**COMMENTARY ON STUDIES OF ^{36}Cl IN THE
EXPLORATORY STUDIES FACILITY AT YUCCA
MOUNTAIN**

**Nuclear Regulatory Commission
Contract NRC-02-93-005**

**Center for Nuclear Waste Regulatory Analyses
San Antonio, Texas**

February 1997

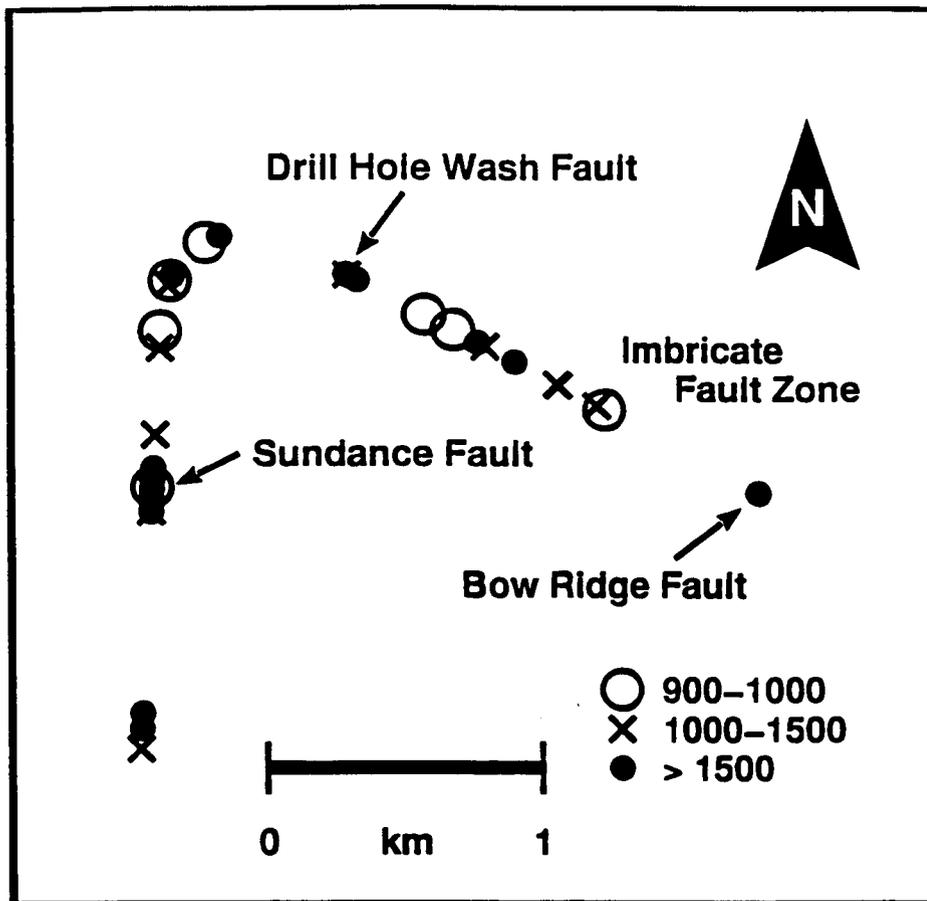
in excess of $1,500 \times 10^{-15}$ constitute 21 of 110 samples reported in Fabryka-Martin et al. (1996a) and occur in eight fairly localized areas (figure 4-1). Samples with values of $^{36}\text{Cl}/\text{Cl}$ greater than $1,000 \times 10^{-15}$ number 34 in this data set, or nearly a third of all samples. Although these additional samples are from somewhat more widely distributed locations along the ESF than unambiguously contaminated samples with $^{36}\text{Cl}/\text{Cl}$ greater than $1,500 \times 10^{-15}$, many samples with $^{36}\text{Cl}/\text{Cl}$ between $1,000 \times 10^{-15}$ and $1,500 \times 10^{-15}$ are located in the eight zones of unambiguous contamination noted above. One additional clustered group of samples with reported $^{36}\text{Cl}/\text{Cl}$ values at $1,100 \times 10^{-15}$ to $1,200 \times 10^{-15}$ occurs in intact bedrock from a subunit contact at 1,056–1,062.5 m from the north portal and about 150 m below the surface expression of the western part of the Imbricate Fault Zone (figure 4-1). The general pattern observed of bomb pulse contamination in groundwater from rocks associated with fault zones at the ground surface is largely preserved by inclusion of the $1,000 \times 10^{-15}$ to $1,500 \times 10^{-15}$ $^{36}\text{Cl}/\text{Cl}$ ratio population. If samples containing $^{36}\text{Cl}/\text{Cl}$ greater than 900×10^{-15} are assumed to represent bomb pulse contamination, the general interpretation of ^{36}Cl data from the ESF begins to change from several isolated zones of fast groundwater flow and bomb pulse contamination to fairly widespread bomb pulse contamination and isolated zones of uncontaminated groundwater (figure 4-1).
